RE: Data Response, Set 2A
Ivanpah Solar Electric Generating System (07-AFC-5)

Ivanpah Solar Electric Generating System (ISEGS)

Data Response, Set 2A

FIGURE 3-9
Sheet 9 of 18
Ephemeral Washes Map
Ivanpah Solar Generating System

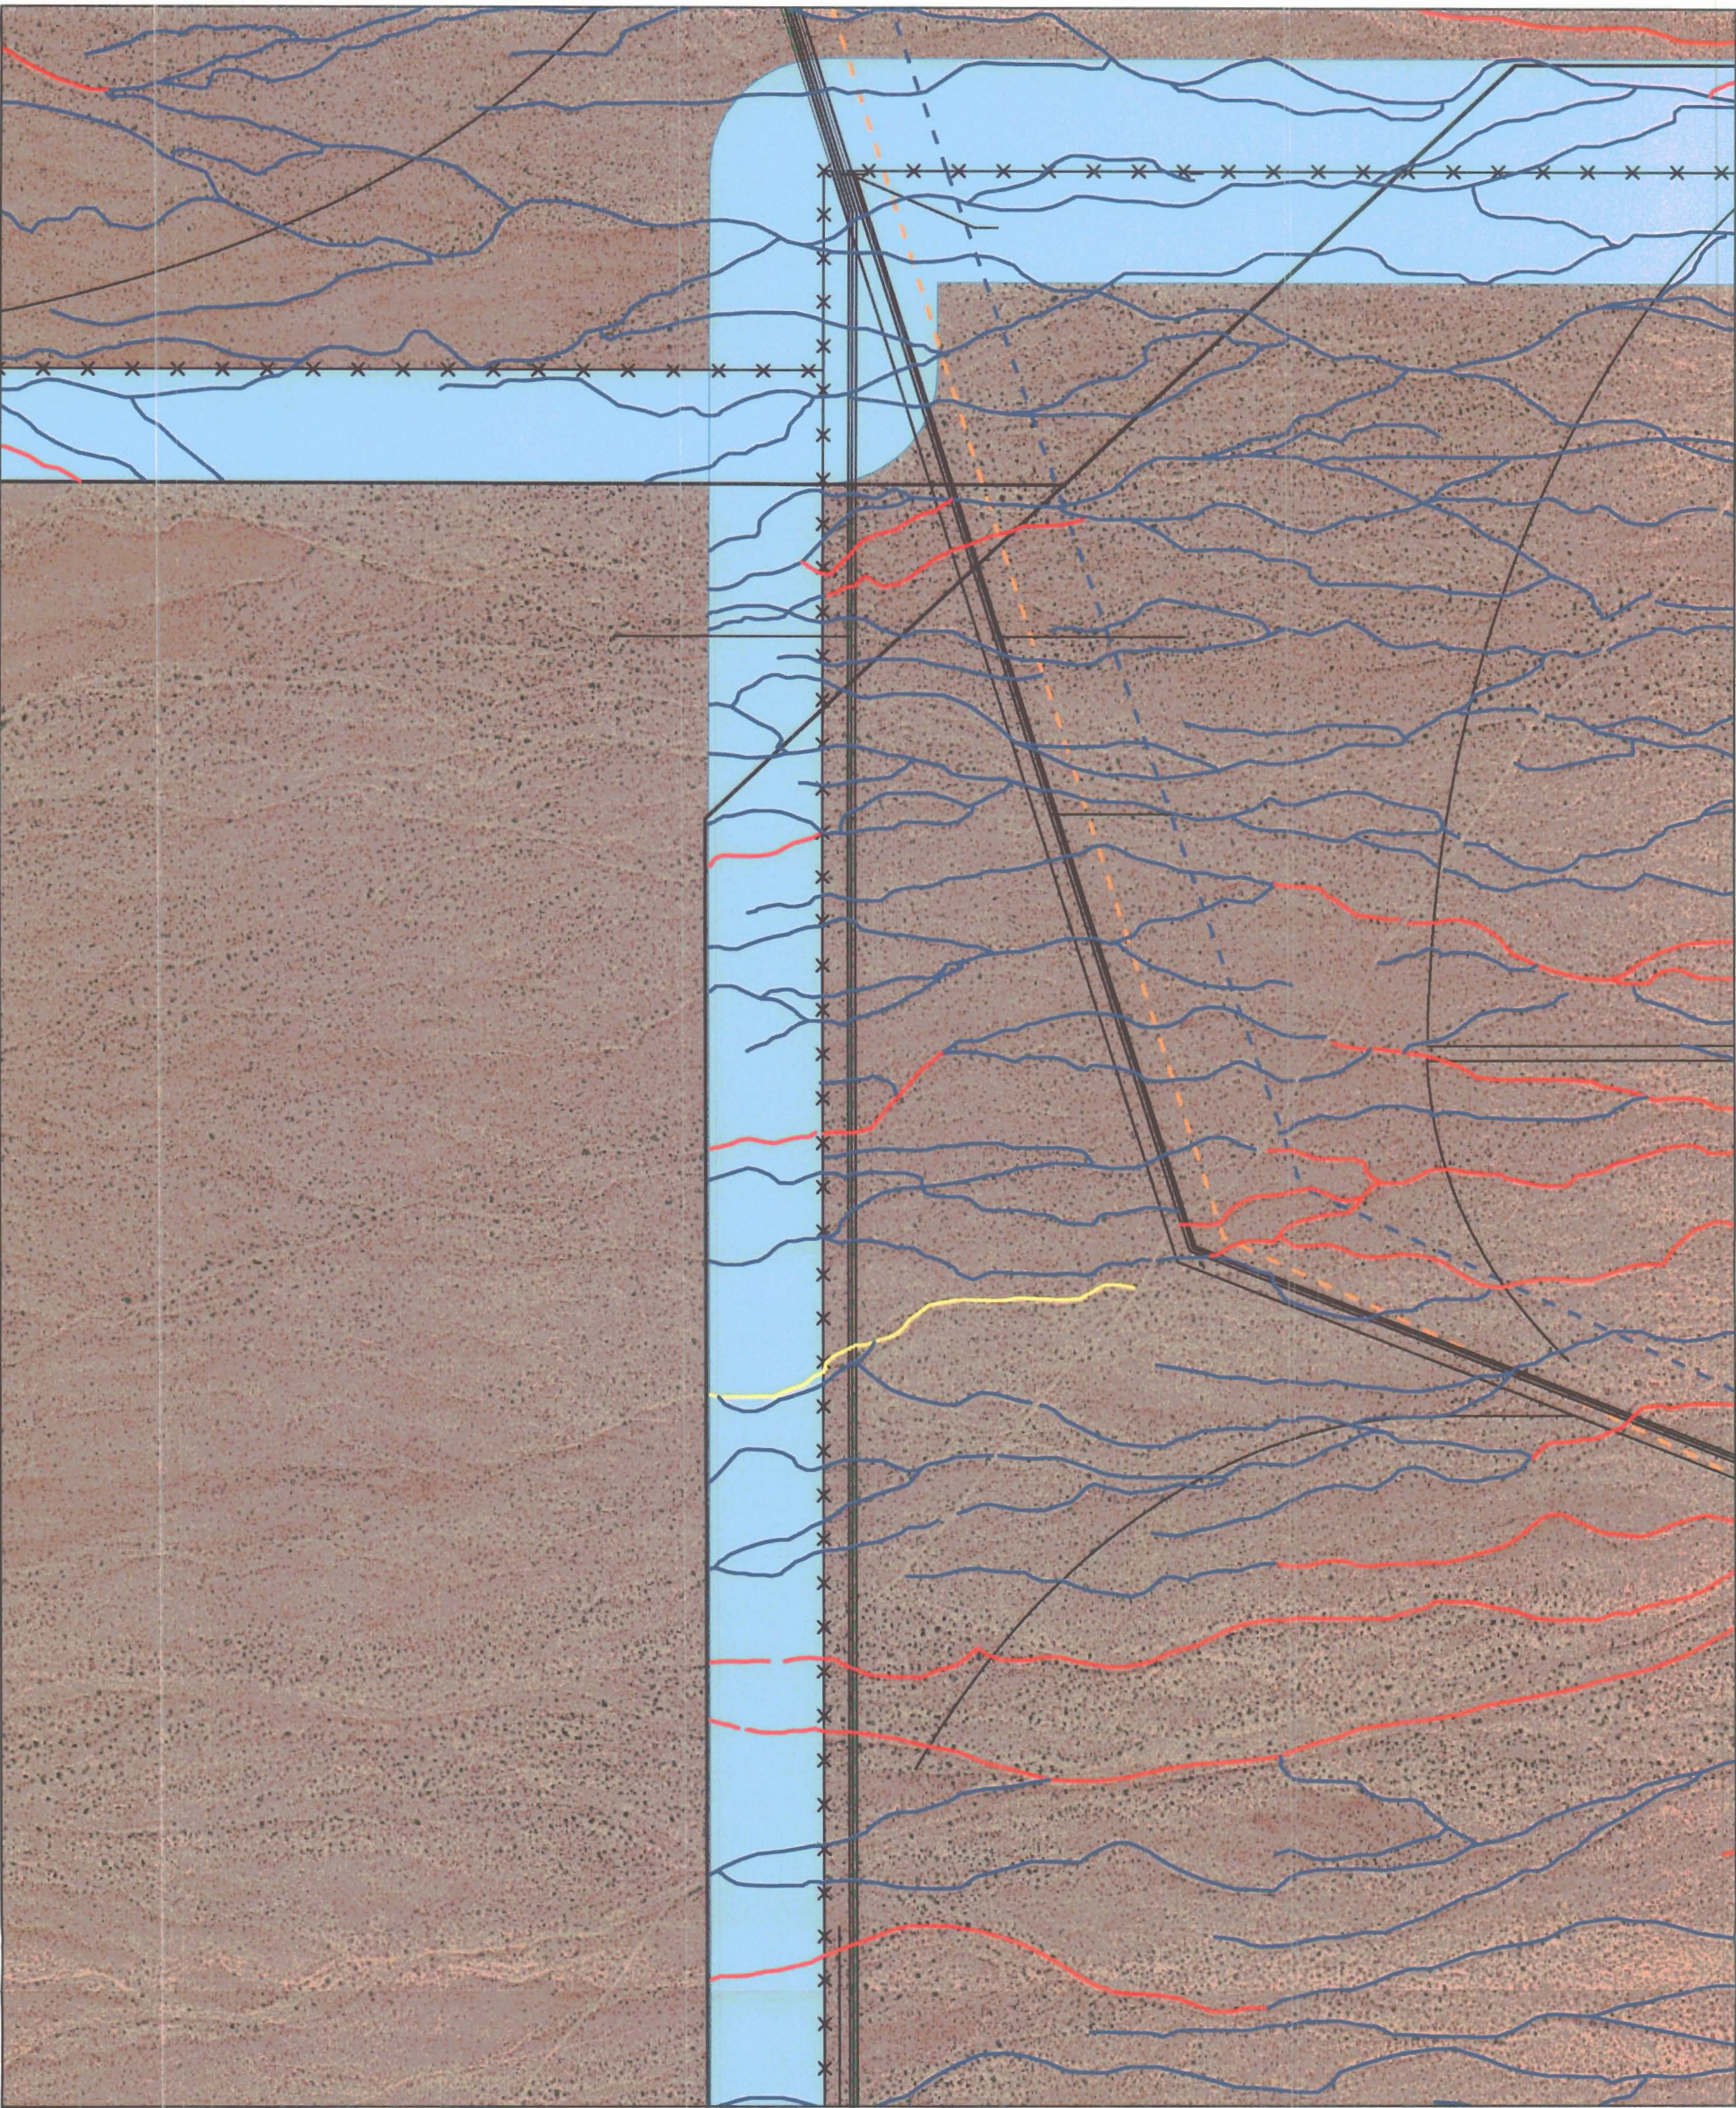
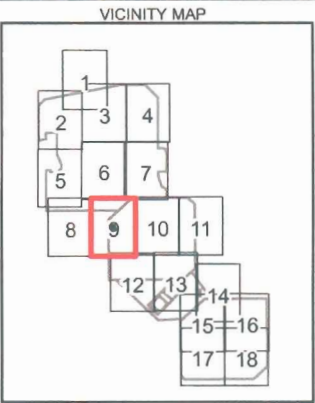
- f. Figure 3-9 of the draft DESCP has errors in the form of seemingly random lines on the figure. It appears to be the result of a printing malfunction or error in the graphic computer file. Please correct this figure.

Response: A revised printout of Figure 3-9 is provided at the end of this section.
